Cambridge Citizens for Liveable Neighborhoods Inc

We've been following the progress of design development of the Harvard Inn at Quincy Square. Along with Gladys Gifford of the Harvard Square Defense Fund, John Pitkin of the Mid-Cambridge Neighborhood Association, and Frankie Lieberman of the Mid-Cambridge Neighborhood Conservation District, we believe that the current design for this structure is too tall, too close to Harvard Street, or both. Inspectional Services, however, believes that this structure is zoning-legal.

Comm. from CCLN relative to the design
development of the Harvard Inn at Quincy Square.

ZONING PUZZLE OF THE MONTH

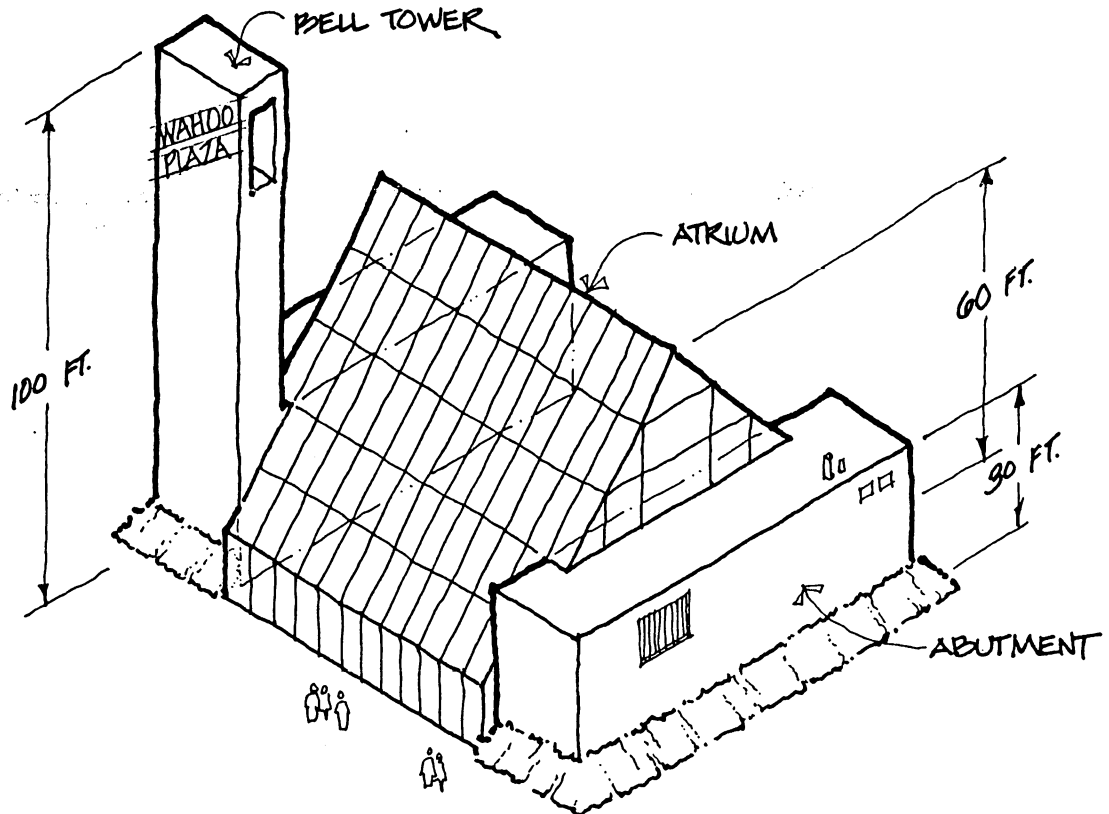
Cambridge zoning says building height is "the vertical distance of the highest point of the roof above the mean grade of the ground adjoining the building". So...

Q: How tall is this building?

NOT 100 FT: Spires and towers of less than 10% of the lot area are not governed by height limits.
NOT 60 FT: The glass roof of the atrium is a skylight, and is exempted from height limits. (Nothing in the ordinance limits how big a "skylight" is relative to a "roof".)
NOT 30 FT: The upper halves of the abutments have fans in them, and are actually mechanical penthouses. "Appurtenances" like penthouses (which can be as large as one third of the plan area) are exempt from height limits.

So: The only part of this structure which potentially meets the zoning ordinance definition of roof is the floor of the mechanical penthouse, which is 15 feet above the floor of the atrium.

BUT: Dirt and groundcover have been piled up around the edges of the abutments to a height of 6 feet, and height is measured from grade adjoining the building, so the right answer is:

9 Feet Yes, measured according to the rules of Cambridge zoning, this building is 9 feet tall.
